The title "Development Application ACCESS REPORT" is displayed in a large, bold, black sans-serif font. The word "ACCESS" is significantly larger and bolder than the other words. The background of the page features a large blue diagonal shape on the left and a grey diagonal shape at the bottom, with a photograph of a wheelchair and a person's feet on a textured surface.

Reference Number: 20156

Site Address: 638 Pittwater Road, Brookvale, NSW

Executive Summary and Design Compliance Statement

Level 3 fire stairs

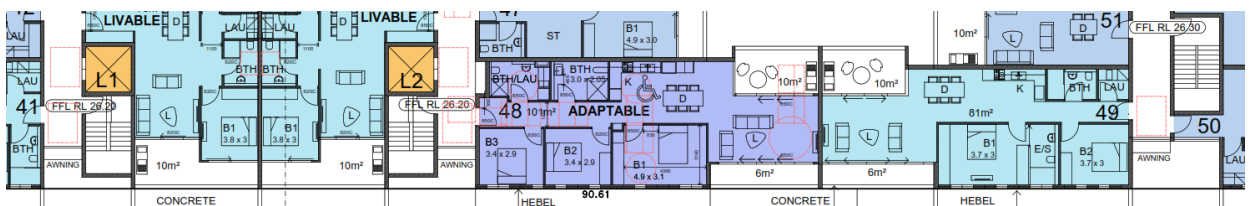
- Ensure either delete first riser going up on all levels OR provide min. 300mm handrail extensions at each mid landing to achieve handrail compliance for fir stairs. This comment also applies to fire stairs on Level 3.

Basement B3

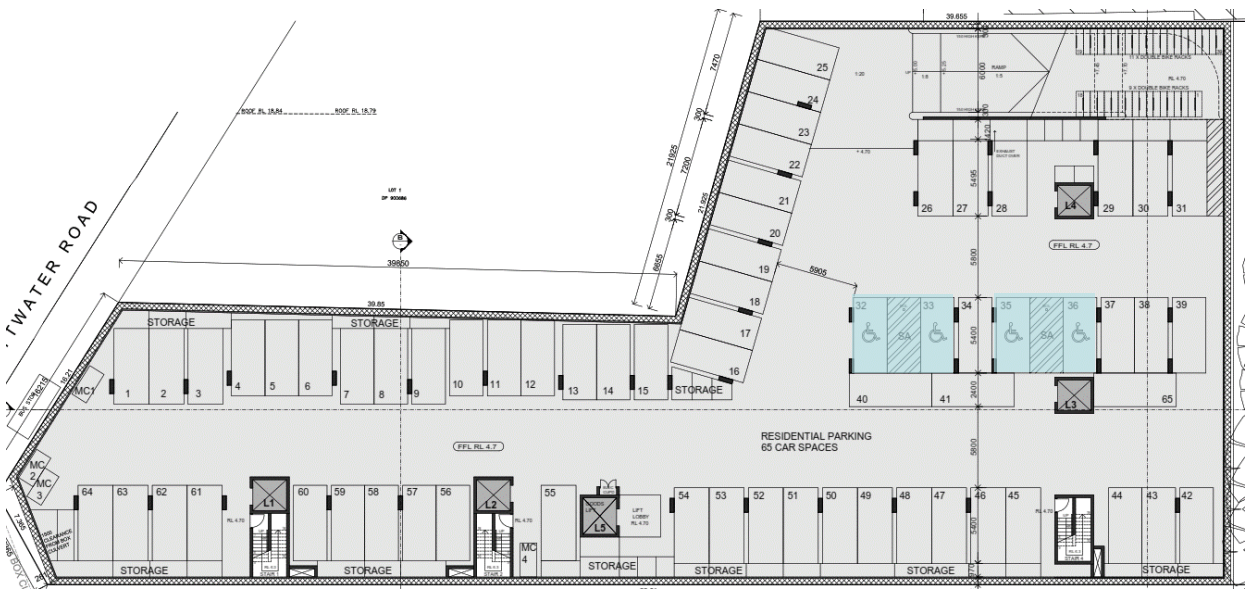
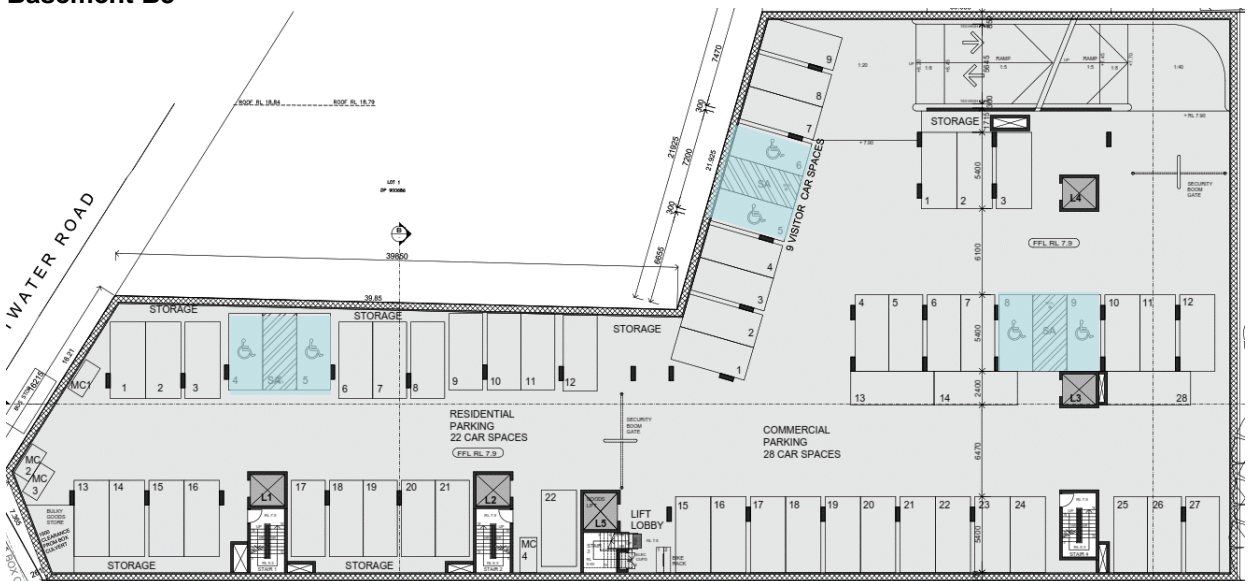
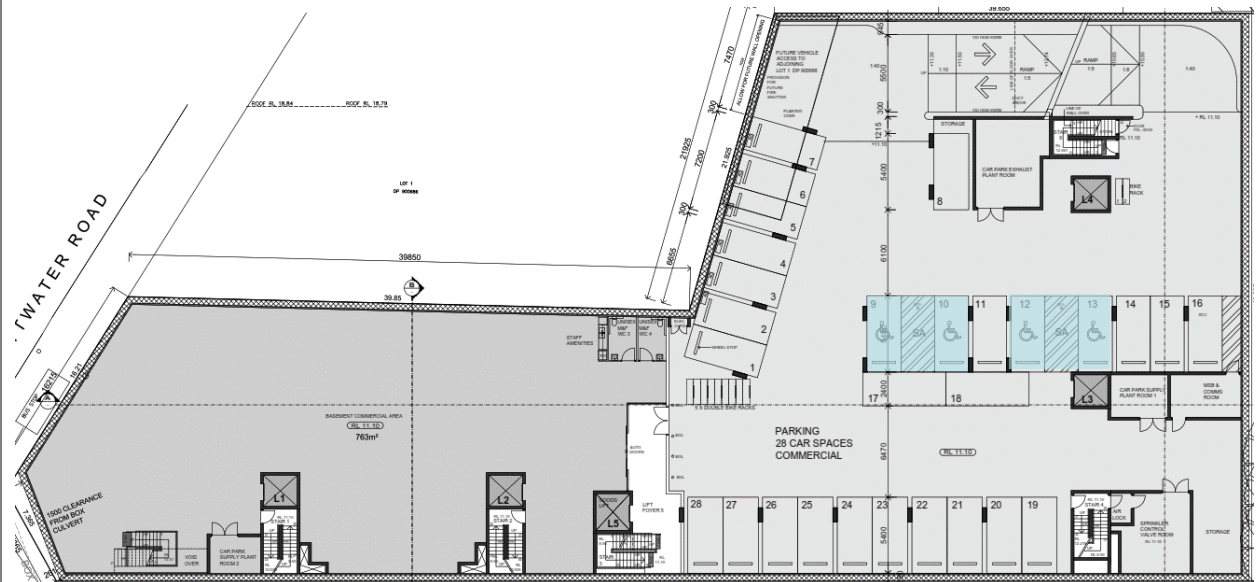
Total number of Accessible parking spaces required for the commercial component of the development = 2.

Total number of Accessible parking spaces provided for the commercial component of the development = 8.

Unit 46

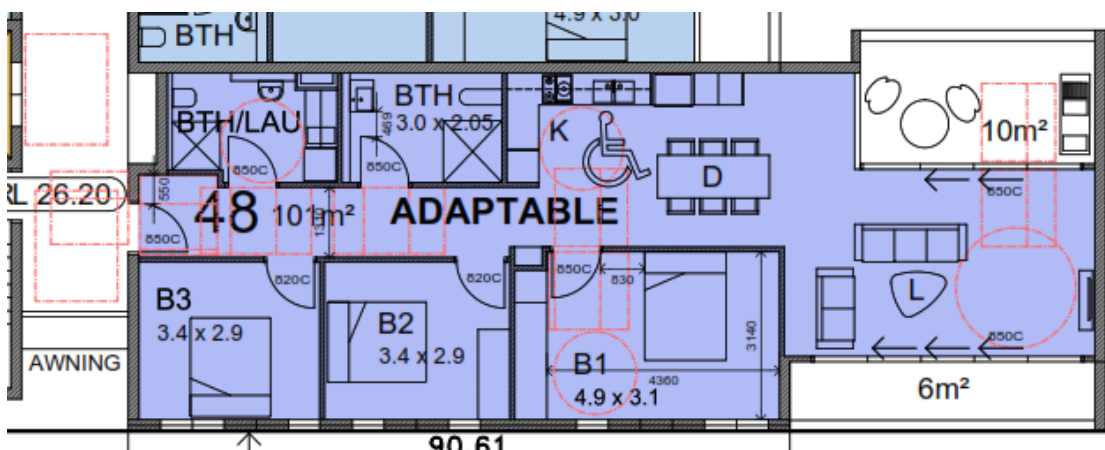
By incorporating the essential requirements listed Checklist below in the Specifications, the nominated Adaptable units can achieve full compliance with Adaptable House Class C

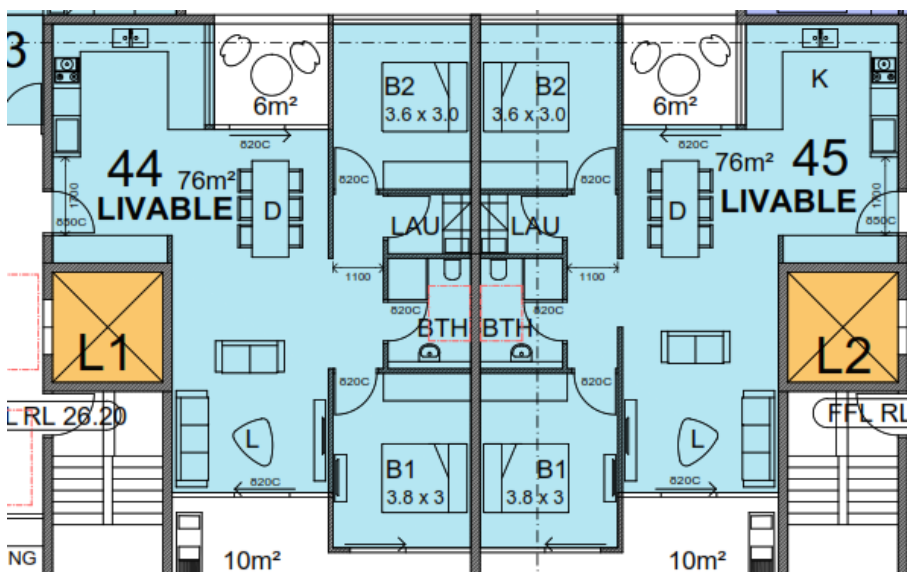
- Ensure ALL doorways in silver livable units incl. L'dry room doors are provided as 820mm clear opening.
- Ensure a clear space of 900x1200mm (clear of any encroachment including door swing) is provided in front of the pan in all silver livable compliant toilet.
Updated plans required at CC stage of works.
